EXHIBIT 7

July 26, 2019

As you requested, this is a letter report on the vegetation management field inspections ("VM inspections") the Monitor team is conducting pursuant to the Court's April 3, 2019 Order ("April 3 Order"). This submission includes: (1) background information on the VM inspections; (2) an explanation of the VM inspections process; (3) the Monitor team's preliminary observations; (4) PG&E's feedback based on the Monitor team's preliminary findings; (5) the Monitor team's preliminary suggestions to PG&E, as shared with the Company on July 17, 2019; and (6) concluding thoughts.

I. OVERVIEW AND BACKGROUND

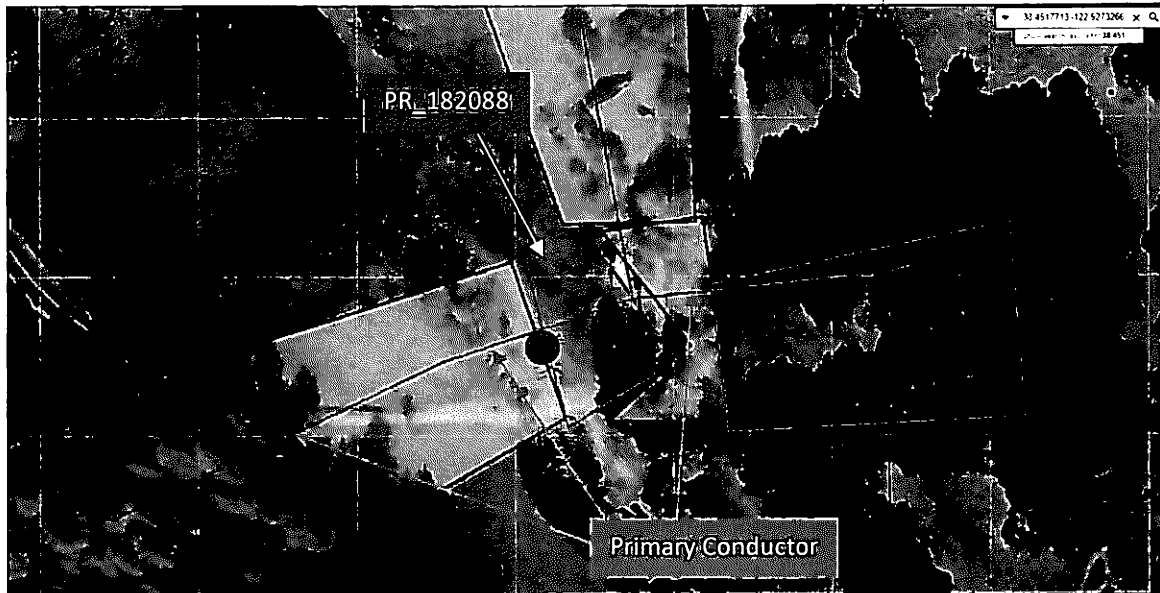
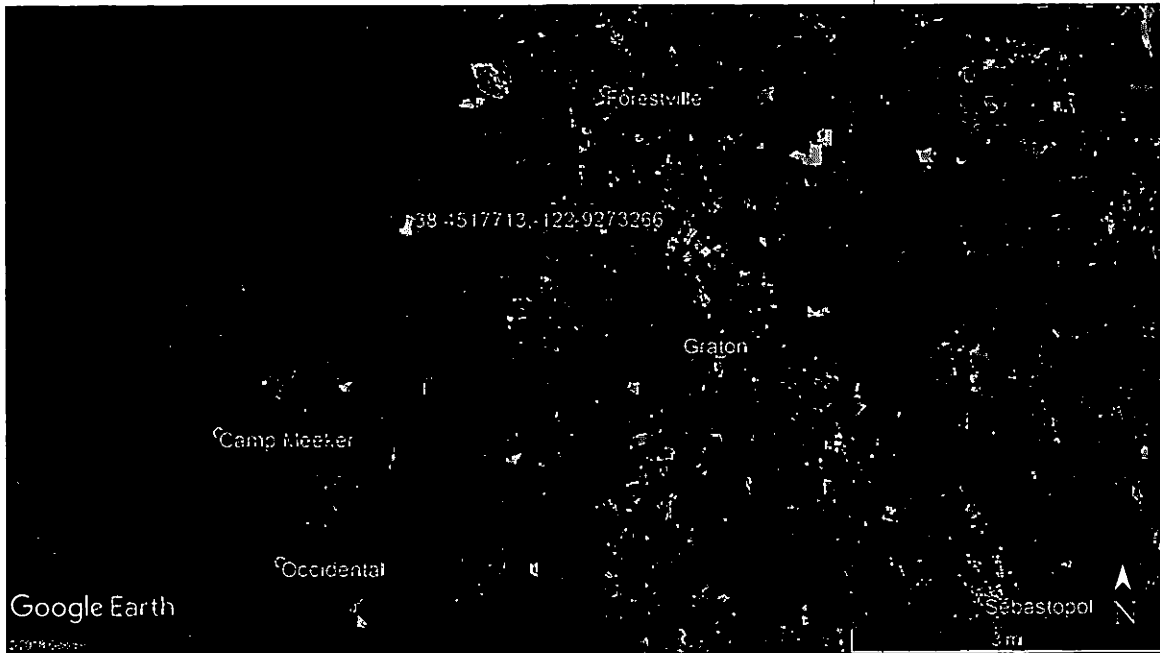
A potential radial clearance tree was found during a Monitor Inspection on June 28, 2019 of Project *PR_182088* on Circuit *Molino 1102*. In general terms, this circuit is located on the outskirts of the city of Sebastopol, CA, running approximately 10 miles to the west of the city. This circuit is located in/near a Tier 3 fire threat area pursuant to the ArcCollector database. The approximate position of the tree is denoted as the red circle in the second graphic below.

PG&E ArcCollector Project Status	Work Identified	
Monitor Team Observed Tree Work in Immediate Vicinity of Subject Tree	No	
Monitor Team Observed Recent Tree Work on Subject Tree	No	
Tree Paint or Other Markings Observed	No paint observed	
Species	Ash	
GPS Coordinates	38.4517713, -122.9273266	
Approx. Distance from Primary Conductor	Trunk of tree 4 feet south	
Approx. Height	26 feet	
Veg Type	Potential Radial Clearance Tree	
Monitor Arborist Comment	Vegetation observed within 4 feet of primary conductor, and tree not visibly marked for pruning

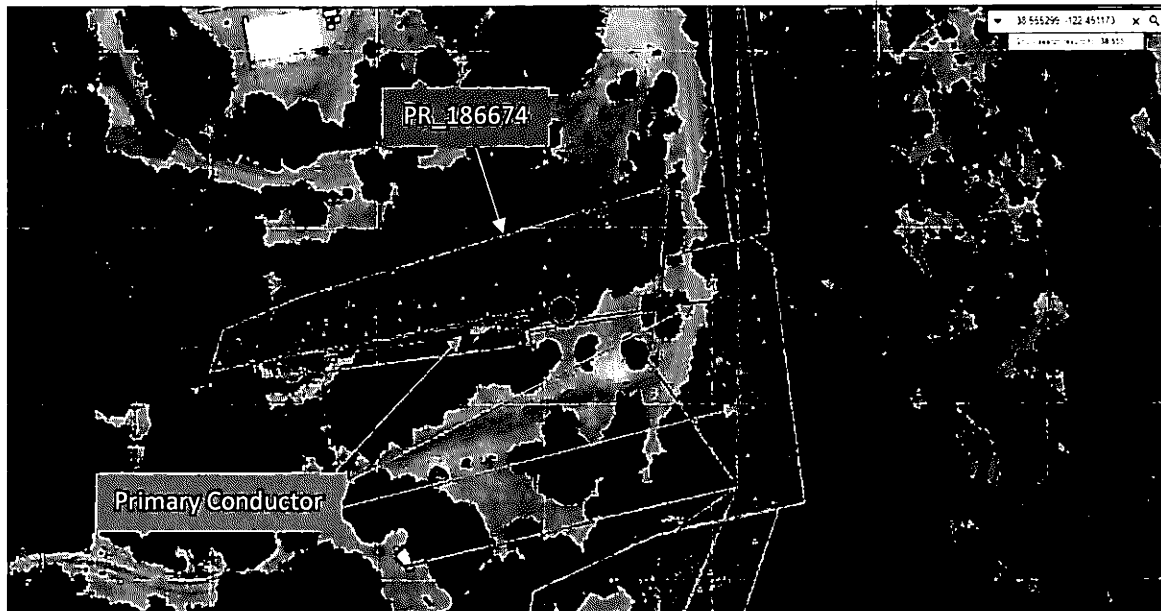
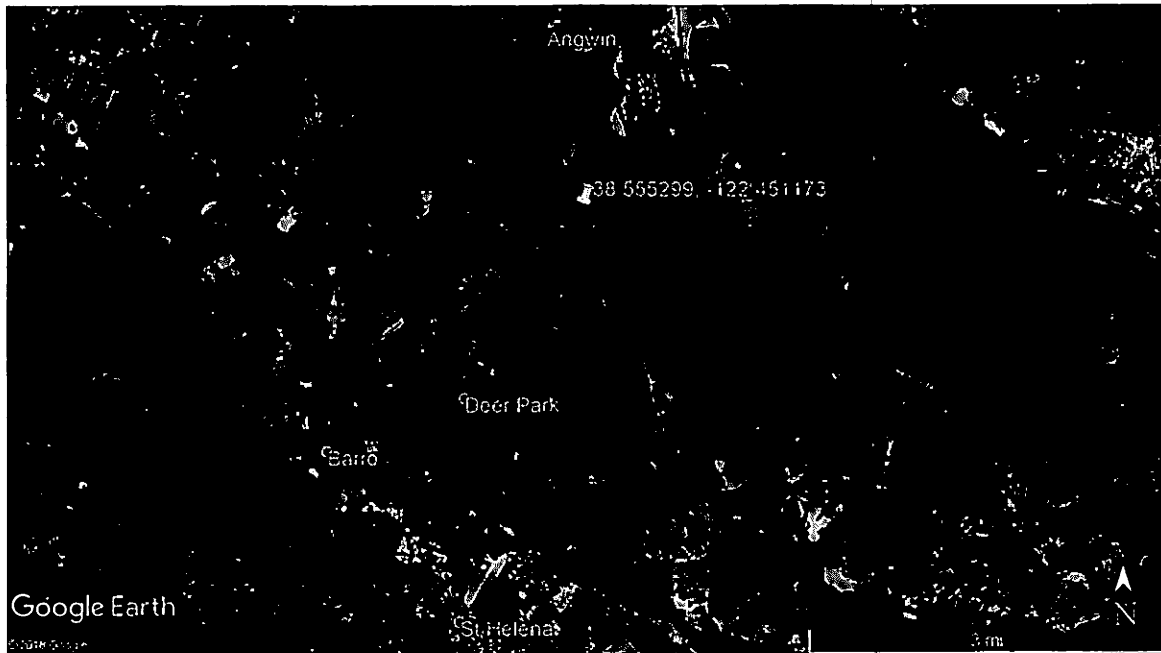
A potential radial clearance tree was found during a Monitor Inspection on June 25, 2019 of Project *PR_186674* on Circuit *Silverado 2104*. In general terms, this circuit is located on the outskirts of the city of St. Helena, CA, running approximately 15 miles to the north of the city. This circuit is located in/near a Tier 3 fire threat area pursuant to the ArcCollector database. The approximate position of the tree is denoted as the red circle in the second graphic below.

PG&E ArcCollector Project Status	Wood Mgmt Complete
Monitor Team Observed Tree Work in Immediate Vicinity of Subject Tree	Yes
Monitor Team Observed Recent Tree Work on Subject Tree	No
Tree Paint or Other Markings Observed	No paint observed
Species	Douglas Fir
GPS Coordinates	38.555299, -122.451173
Approx. Distance from Primary Conductor	Trunk of tree 2 feet north
Approx. Height	30 feet
Veg Type	Potential Radial Clearance Tree
Monitor Arborist Comment	Vegetation observed within 4 feet of primary conductor

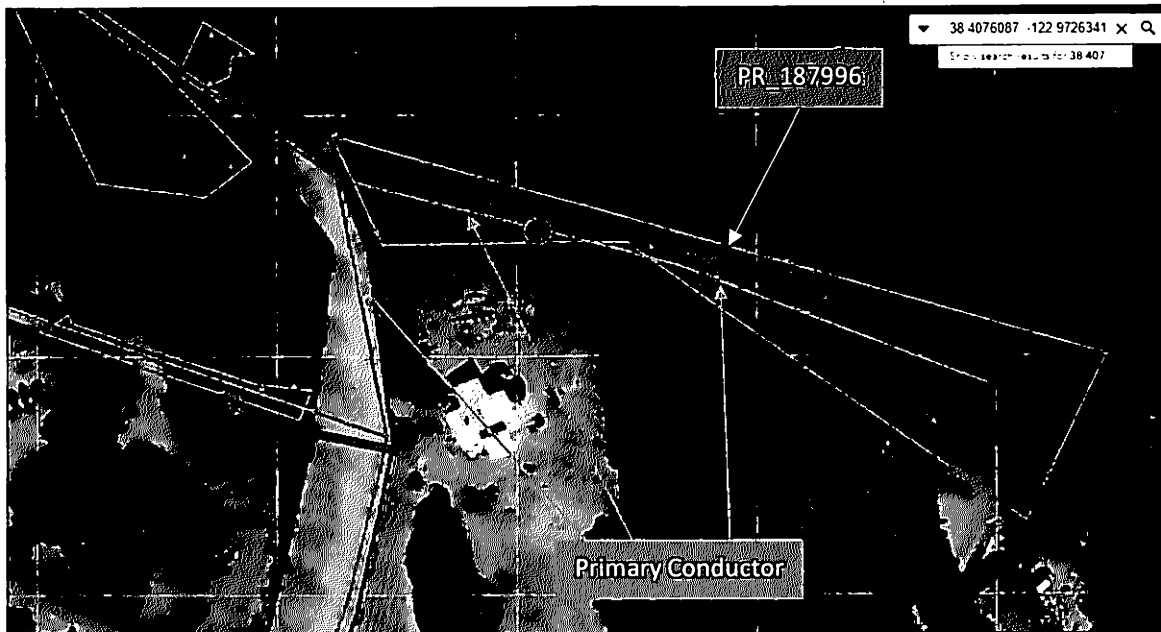
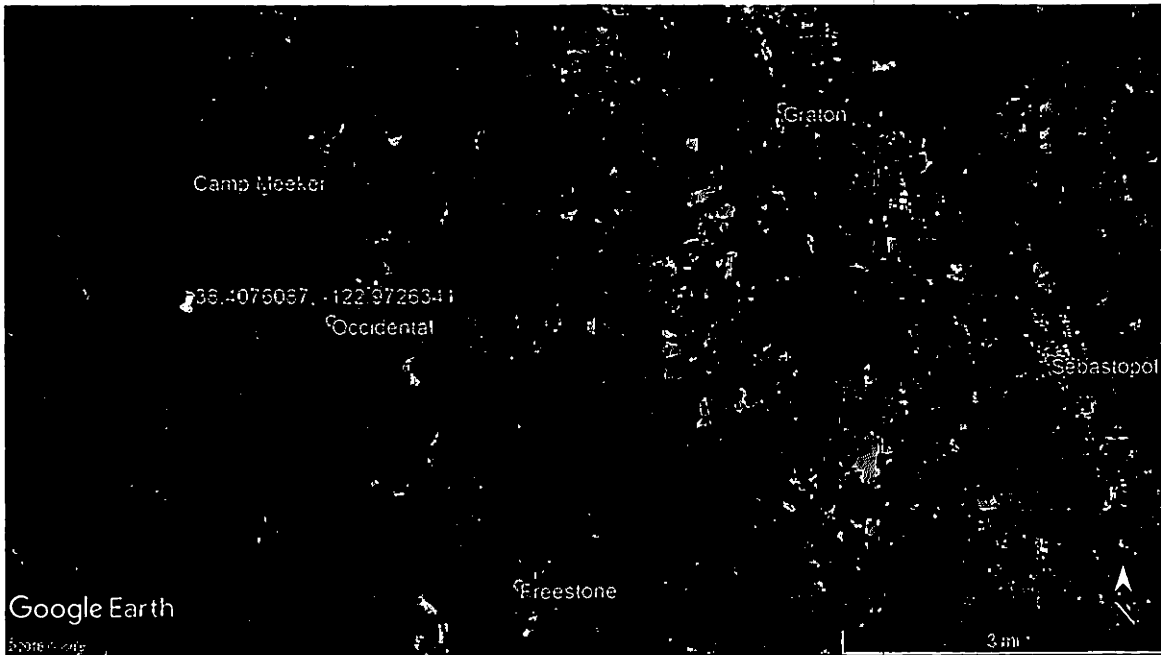
A potential radial clearance tree was found during a Monitor Inspection on July 1, 2019 of Project *PR_187996* on Circuit *Molino 1102*. In general terms, this circuit is located on the outskirts of the city of Sebastopol, CA, running approximately 10 miles to the west of the city. This circuit is located in/near a Tier 3 fire threat area pursuant to the ArcCollector database. The approximate position of the tree is denoted as the red circle in the second graphic below.

PG&E ArcCollector Project Status	Work Identified	
Monitor Team Observed Tree Work in Immediate Vicinity of Subject Tree	No	
Monitor Team Observed Recent Tree Work on Subject Tree	No	
Tree Paint or Other Markings Observed	No paint observed	
Species	Coastal Redwood	
GPS Coordinates	38.4076087, -122.9726341	
Approx. Distance from Primary Conductor	Trunk of tree 2 feet south of the primary conductor	
Approx. Height	25 feet	
Veg Type	Potential Radial Clearance Tree	
Monitor Arborist Comment	Vegetation observed within 4 feet of primary conductor, and tree not visibly marked for pruning.

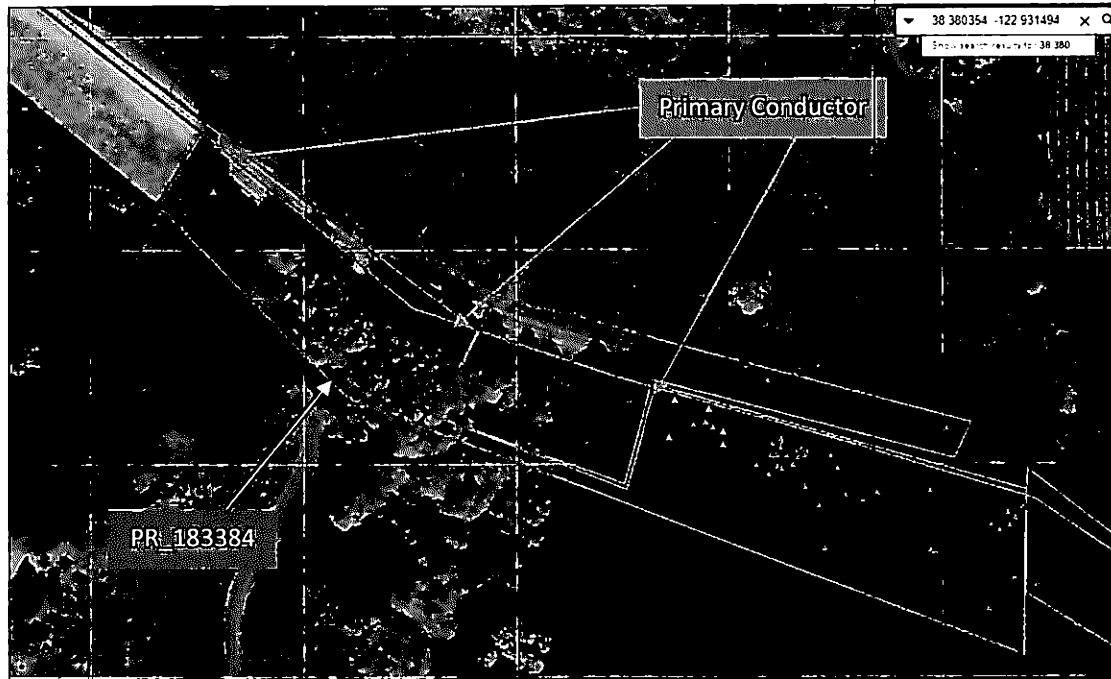
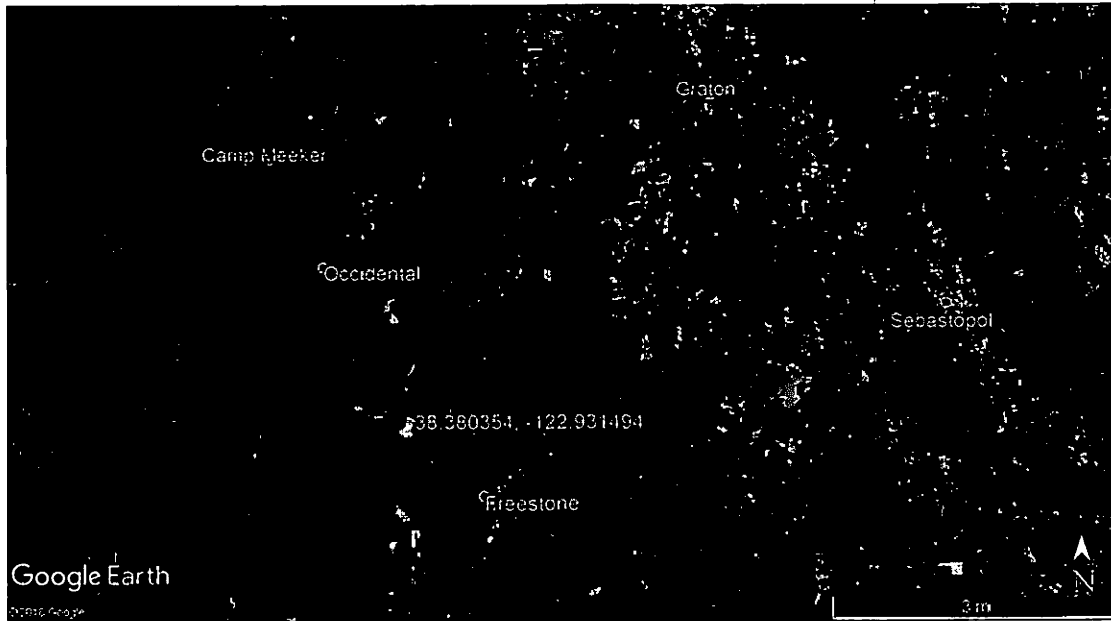
A potential radial clearance tree was found during a Monitor Inspection on July 12, 2019 of Project *PR_183384* on Circuit *Molino 1102*. This report follows up on an email to the Company on July 12 regarding this tree and Project. In general terms, this circuit is located on the outskirts of the city of Sebastopol, CA, running approximately 10 miles to the west of the city. This circuit is located in/near a Tier 3 fire threat area pursuant to the ArcCollector database. The approximate position of the tree is denoted as the red circle in the second graphic below.

PG&E ArcCollector Project Status	Work Identified
Monitor Team Observed Tree Work in Immediate Vicinity of Subject Tree	No
Monitor Team Observed Recent Tree Work on Subject Tree	No
Tree Paint or Other Markings Observed	Flagging observed
Species	Ash
GPS Coordinates	38.380354, -122.931494
Approx. Distance from Primary Conductor	Trunk of tree 20 feet southwest
Approx. Height	32 feet
Veg Type	Potential Radial Clearance Tree
Monitor Arborist Comment	Vegetation observed within 4 feet of primary conductor, and tree has potentially been in contact with the primary conductor, as what appear to be singed branch tips can be observed from the ground.
